NP-11-0037  
August 4, 2011

Subject: Exelon Nuclear Texas Holdings, LLC  
Victoria County Station Early Site Permit Application  
Response to Request for Additional Information Letter No. 07  
NRC Docket No. 52-042

**RAI 02.05.02-3 a, b, c:****Question:**

Figure 1: Location of Dames & Moore Zones 26, 26b, and 27.

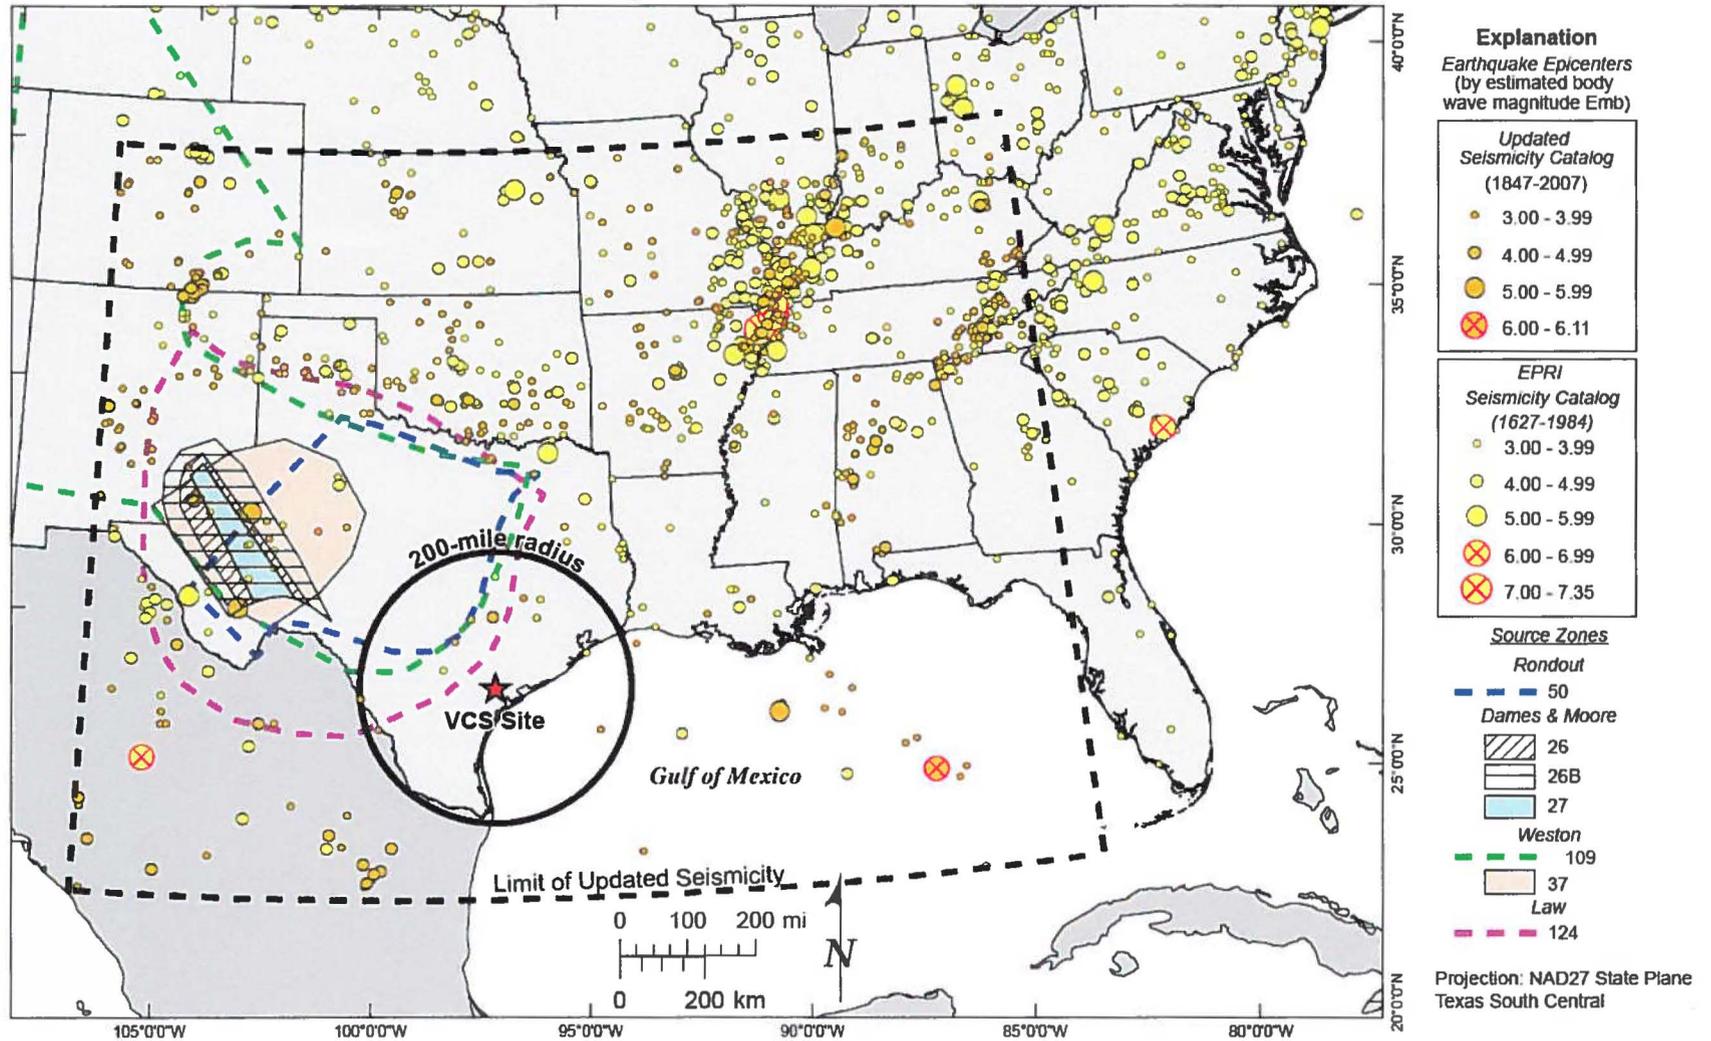
- (a) As shown in SSAR Figure 2.5.2-5, the boundary of the Dames and Moore New Mexico source (67) appears to include a reentrant that loops northwestward from the northern boundary of the Quachitas Fold belt through southeastern New Mexico and back. This feature does not appear to be represented by any of the Dames and Moore sources but encloses the January 2, 1992, and April 14, 1995, earthquakes [magnitudes (Emb) 5.0 and 5.6, respectively]. Please discuss this source's contribution to the VCS site hazard in light of this reentrant feature.

(a) As described in SSAR Section 2.5.2.2.1 and 2.5.2.2.1.2, SSAR Figure 2.5.2-5 shows the EPRI-SOG source zones for the Dames & Moore Earth Science Team (EST) that are within 200 miles of the VCS site. The "reentrant" in SSAR Figure 2.5.2-5 that is noted in the RAI question as not having a source zone is over 250 miles from the VCS site, and therefore the source zone for that region was not included in the figure. This "reentrant" region is filled by the Delaware Basin (zone 26), the Delaware Aulacogen (zone 27), and the default zone for zones 26 and 27 (zone 26b) (Figure 1) (EPRI, 1989). The general approach used to select potential source zones to be included in the source model is based on guidance discussed in Section 5.5.1 of the EQHAZARD Primer (EPRI, 1989) titled "*Selection of Seismic Sources-Development of Source Files*", which states:

Based on this guidance, all sources within 200 miles (320 kilometers) of the VCS Site were included in the seismic source model (which is a greater distance than the 200 kilometer distance suggested by the EQHAZARD Primer). Thus, zones 26, 26b, and 27 were screened out of the seismic hazard calculations because they are over 250 miles from the VCS site.

Source zones 26, 27 and 26b were considered in the sensitivity analysis that is discussed in part (c) of this response (see Tables 1 and 2). See part (c) for a detailed discussion. The results of this sensitivity analysis—which incorporated a modified Mmax distribution larger than both the January 2, 1992 5.0 and the April 14, 1995 5.6 earthquakes—demonstrated that the potential impact (in percent difference in rock UHRS values) of the updated characterization is not significant.

Figure 2: Location of Alpine earthquake.

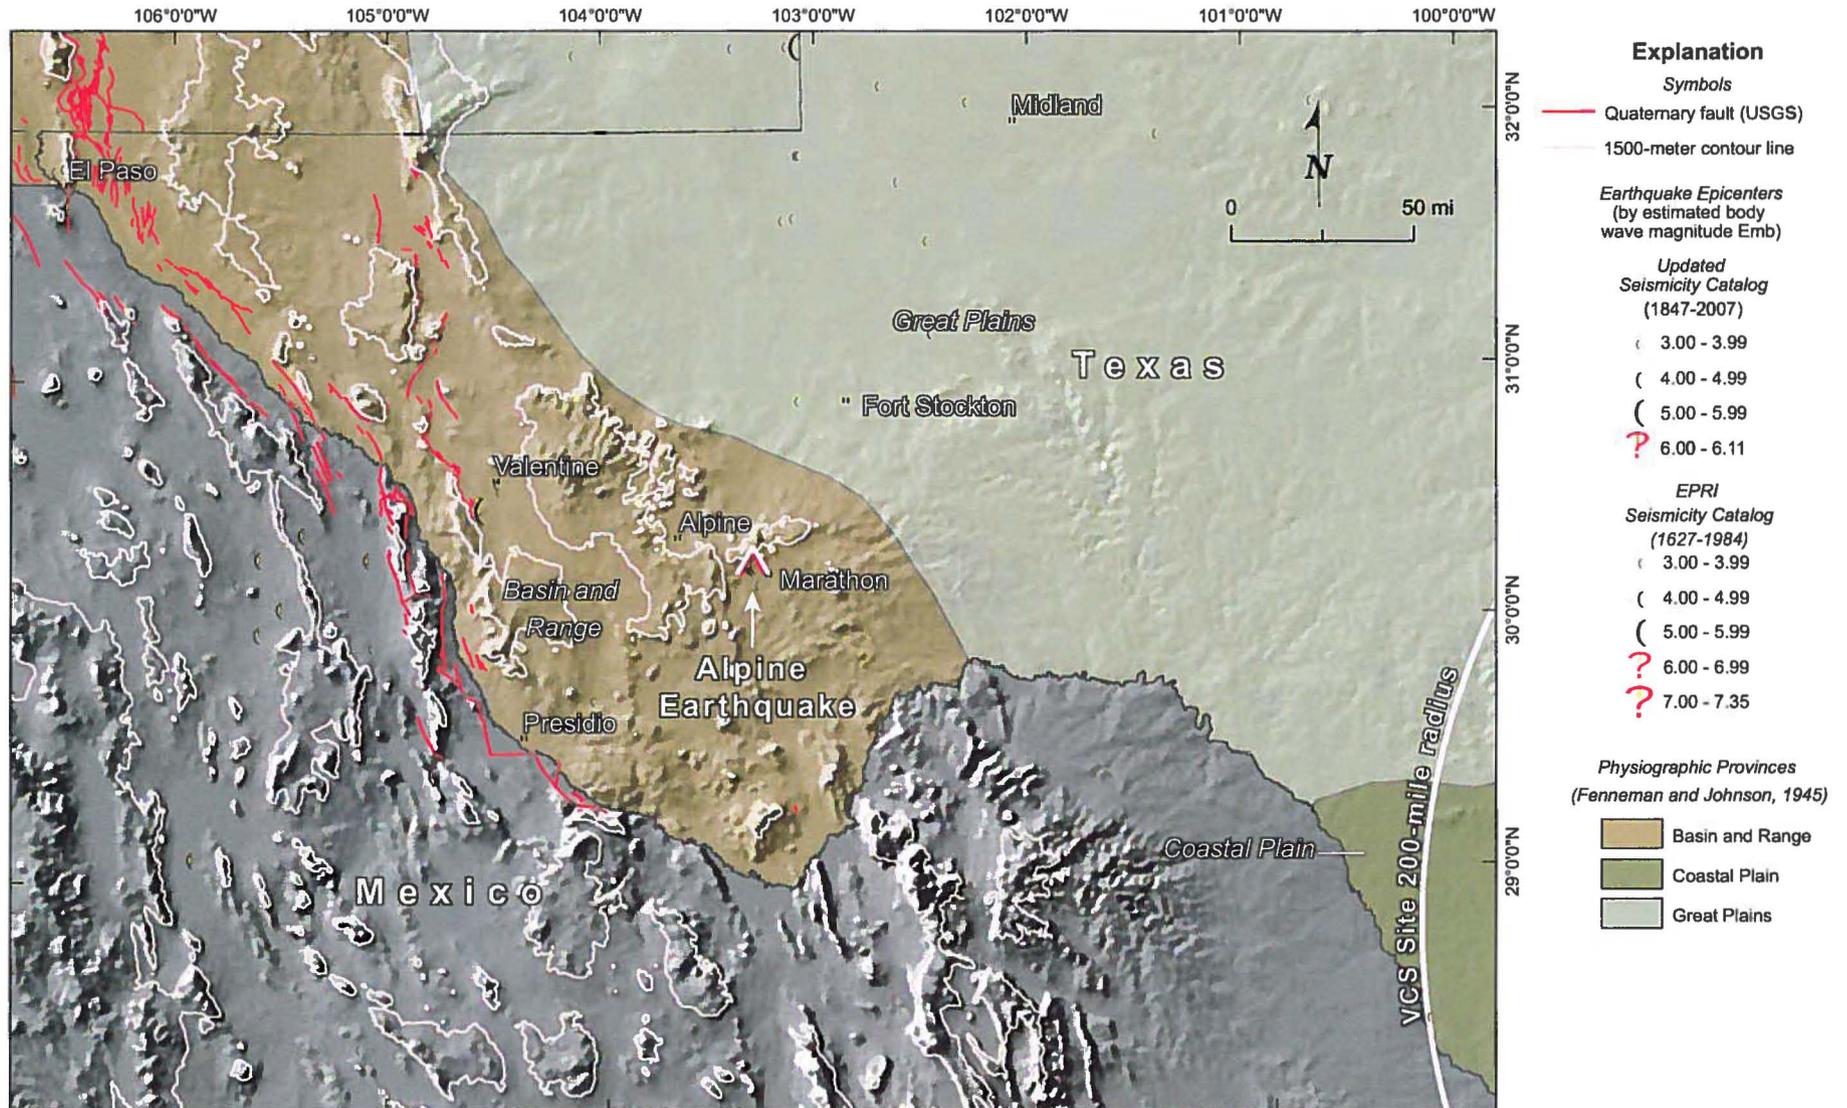
- (c) SSAR Section 2.5.2.4.3 describes the applicant's interpretation of the tectonic environment that produced the moderate-sized (Emb 5.6) earthquake on April 14, 1995 in Western Texas. The applicant created a new seismic source to accommodate potential hazard that results from the Rio Grande Rift (RGR). Please discuss how the applicant reached the conclusion that the April 14, 1995 earthquake is tectonically related to the RGR system. Please also provide further information on how the hazard calculated at the VCS site would be impacted if the applicant updated the EPRI source model parameters that encompass the earthquake rather than attributing the event to an eastward extension of the RGR.

The 14 April 1995, Emb 5.6 Alpine earthquake was felt over an area of approximately 760,000 km<sup>2</sup> and had a maximum intensity of MMI VI (Frohlich and Davis, 2002). Figure 2 shows the general setting of the 1995 Alpine earthquake in relation to physiographic provinces (Fenneman and Johnson, 1946) and the terrain of western Texas, faults from the USGS Quaternary fault and fold database (USGS, 2006), and historical earthquakes (see SSAR Section 2.5.2.1). The CMT focal mechanism for the Alpine earthquake indicates normal slip on moderately dipping nodal planes (Global CMT Project, 2007). It is the second largest earthquake recorded in Texas (the 1931 Valentine earthquake was Emb 5.8). Many small landslides were triggered in the mountains surrounding the epicentral region (Frohlich and Davis, 2002), but no fault-related surface deformation has been identified. Also, the earthquake has not been associated with a causative fault.
